1st review comments - 8-AB-2024 The Collector's Garages at Westworld

Subject Property - Current APN's: 217-14-037A and 217-14-038A

<u>8-AB-2024 - Real Estate case-specific review comments:</u>

ARCHITECTURAL SITE PLANOVERALL

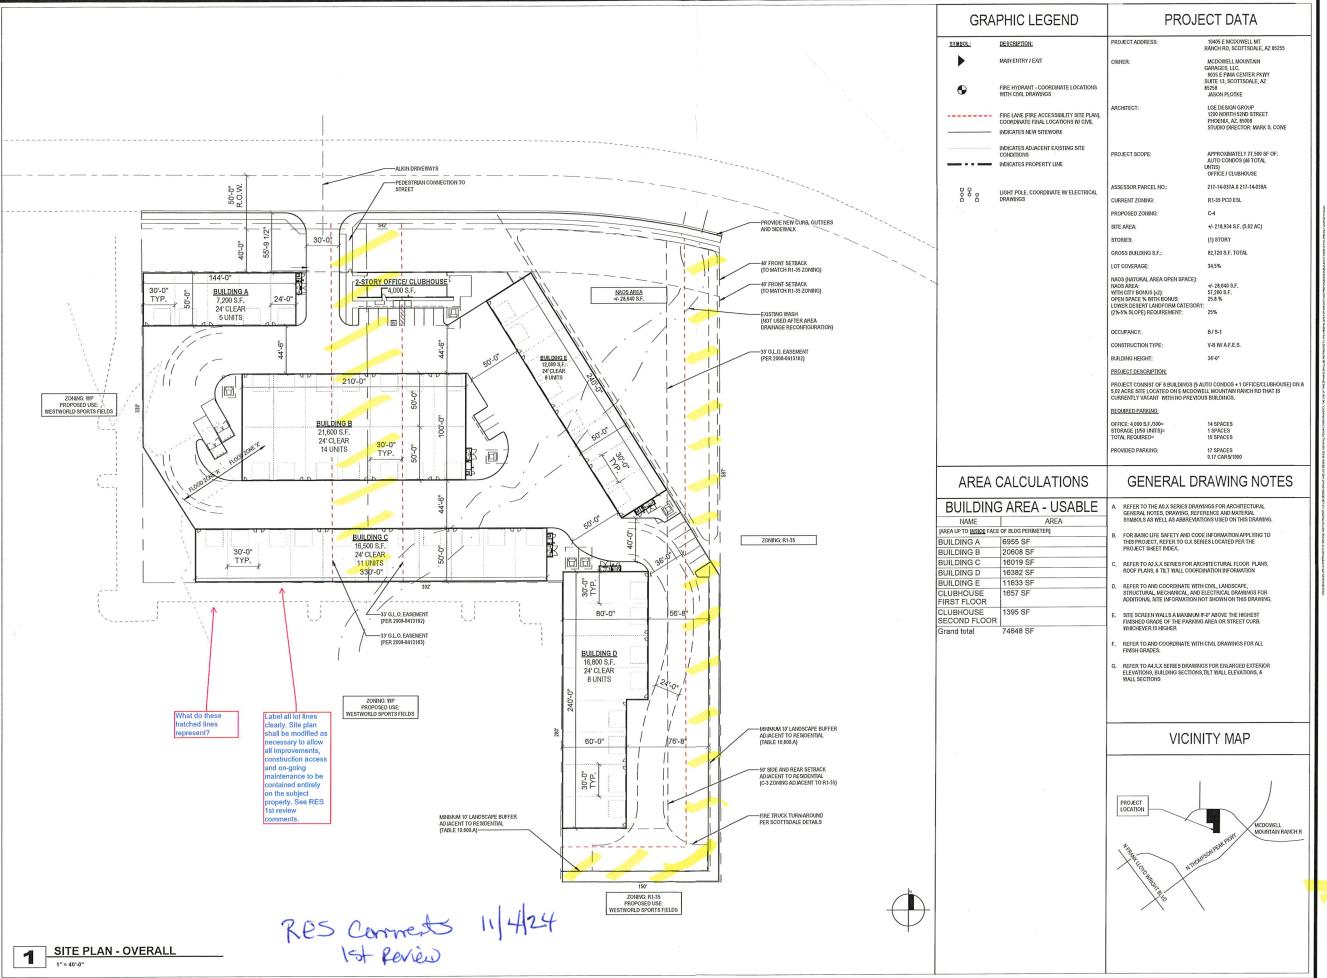
- 2. <u>Site Plan w/ Aerial drawn by LGE Design Group dated September 5, 2024.</u> This site plan sheet for the "APEX Motor Club" is labeled as an Architectural Site Plan. It's not clear if this site plan is the most current plan for "The Collector's Garages at Westworld" development; however, we assumed it is for the purpose of this review. Real Estate comments:

- a. ROW and site dimensions should be consistent with submitted easement release legal descriptions and exhibits prepared by Hunter Engineering as well as the documents that created the lots and rights of way.

- b. The leader-line for the easternmost 33' GLO easement is not leading to the correct line.
 - c. All three references to the document that created the GLO easements are incorrect.

- d. The Westworld Sports Fields have been constructed and an updated aerial is available.
 - e. Please verify the project data, area calculations, and plan labels. Revise as necessary to correct what appear to be inconsistencies in project addressing, proposed new zoning, and improvement details.

- f. The site plan appears to show a zero-lot line build, i.e. vertical improvements proposed to be built on or quite near, along the western lot lines and a southern lot line. In most cases, building and maintaining improvements on or very close to a lot line is not feasible without obtaining an easement from the adjacent land owner. In this case, with the exception of the eastern and southernmost borders of the larger parcel, the adjacent land is owned by the Federal Bureau of Reclamation (BOR). The Central Arizona Project (CAP) manages those parcels on behalf of the BOR. The City of Scottsdale is authorized to improve and use those parcels for recreational purposes only.

The CAP, acting on BOR's behalf, is the only entity that is authorized to issue a temporary or perpetual land right on the adjacent BOR lands. Real Estate is not aware of a scenario in which a private entity has been the recipient of a land right from the BOR for a use such as the one that is proposed for this development. If a land right cannot be obtained, please modify the site plan to allow for all

- improvements, construction access, and operation/ maintenance, to be contained on the subject larger parcels.
- g. Development of the larger parcel as combined is also bound by the terms, restrictions, covenants, conditions, liabilities, and obligations of that certain Drainage Project Agreement recorded as Document No. 2022-0430791 in the Maricopa County Recorder's Office on May 18, 2022. This document is item #9 on Schedule B11 of Amendment 3 to the Applicant's Title Commitment dated September 6, 2024.
